CEQA APPEAL SUMMARY, 3601 – 3615 Mission Road and 2010 – 2036 Lincoln Park Avenue; CF No. 23-0796

City Planning Case No.s: CPC-2022-6189-CU-DB-ZAA-SPR-HCA and ENV-2022-6190-CE

### **Appeal Summary**

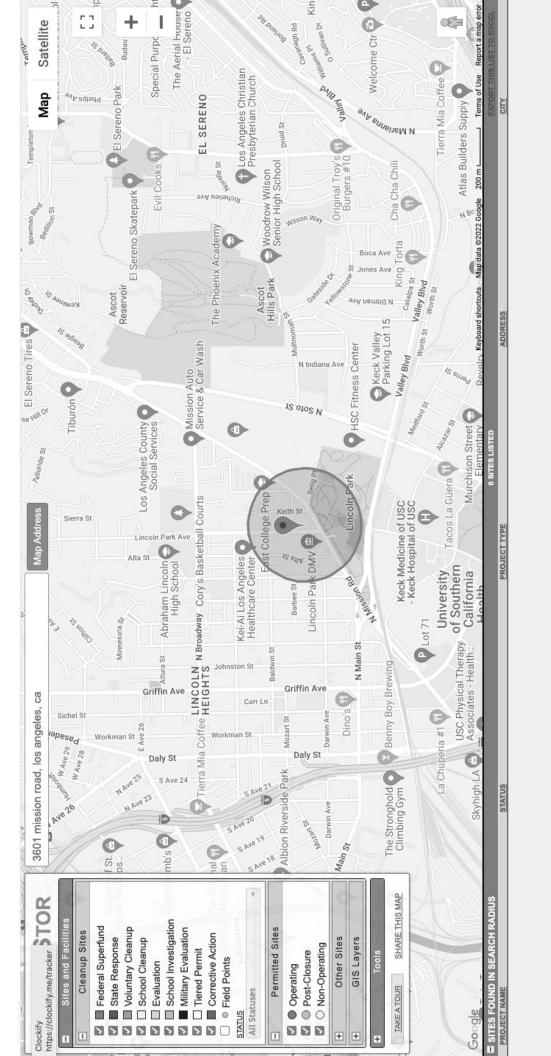
### **APPEAL POINT 22:**

An exception to CE applies due to unusual circumstances: building is taller than other buildings in area, in a liquefaction zone, and will have outdoor balconies that can generate additional air and noise pollution.

The project has a Geotechnical Investigation Report written by Geocon West, Inc. on June 23, 2022 and approved by the City of Los Angeles Department of Building and Safety as documents in a Geology and Soils Report Approval Letter issued on July 28, 2022. Appellants do not provide substantial evidence to support that project geotechnical reports are inadequate or that the conclusions are flawed. Both the Geotechnical Investigation Report written by Geocon West, Inc. and the Geology and Soils Report Approval Letter issued by the City's Department of Building and Safety are attached.

Appellants have failed to provide substantial evidence that any unusual circumstances apply.

Photo 7. View Southwest Across Western Half of Project Site.

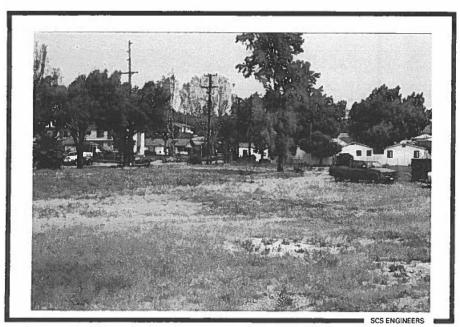
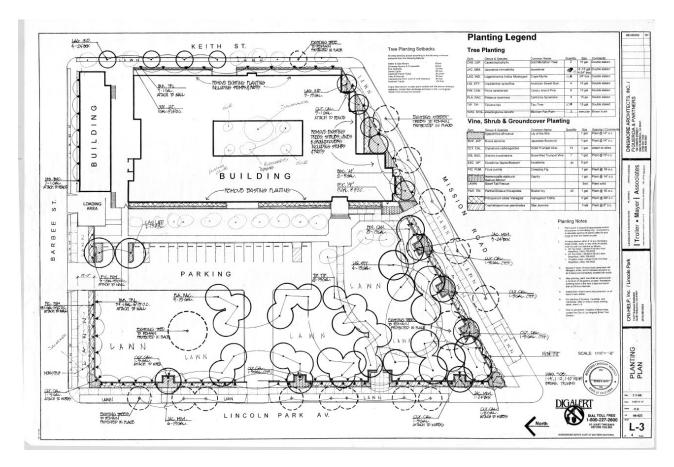
The project will remove 5 protected sycamore trees, that are alive and healthy. Please refer to document (Exhibit C)

The project will remove 5 healthy and protected western sycamore trees or Platanus racemosa (LATPO), developer claims trees were planted recently. In a brief survey within 1320 foot buffer used to denote the access and walk ability of a project, there are 36 western sycamores including the onsite count. Evidence of a mature grove is in the grouping of trees across the street at Lincoln Park. The onsite sycamores appear to be similar in age. In an EIR of Hazard Park development from (2005) reveals the area was marshland extending past Ramona Gardens and possibly as far as the site. The edges of a marshland are the optimal habitat for Western Sycamores. This habitat represents the last of an ancient marshland beneath our feet and pavement. This property is the actual site of the famous Lincoln Heights Alligator Farm, which emphasizes the watershed condition and habitat for the sycamore.

The project would be constructed on an existing paved surface parking lot, and would not require the removal of any area considered green space or open space within City of LA's general plan or zoning guidelines. Additionally, a protected tree report was prepared by UPLA Studio, which determined that there are no trees on site that are protected by the Los Angeles Tree Protection Ordinance that would be impacted by construction. UPLA Studio is a Landscape Architecture firm (Architect License Number 6086) whose Tree Expert, Stephanie Reed, is a Certified Arborist through the International Society of Arboriculture (Certification Number WE-11453A). Their report is included as an attachment to the CE.

The definition of Protected Tree in Section 17.02 of the Los Angeles Municipal Code reads "The definition shall not include any tree or shrub grown or held for sale by a licensed nursery, or trees planted or grown as part of a tree planting program." According to the Protected Tree Report dated September 13, 2022, the Tree Expert observed five (5) Western Sycamore (Platanus racemosa) trees during a field visit on June 30, 2022. However, based on research conducted by the property owner and Tree Expert, the 5 Sycamore trees are grown from nursery stock and, therefore, are not protected by the Los Angeles Tree Protection Ordinance. Previous development plans and historic photos of the

site show evidence that the Sycamore trees are not naturally occurring. A copy of the Protected Tree Report, including photographic evidence that the Western Sycamores were planted as part of a nursery program, is attached.
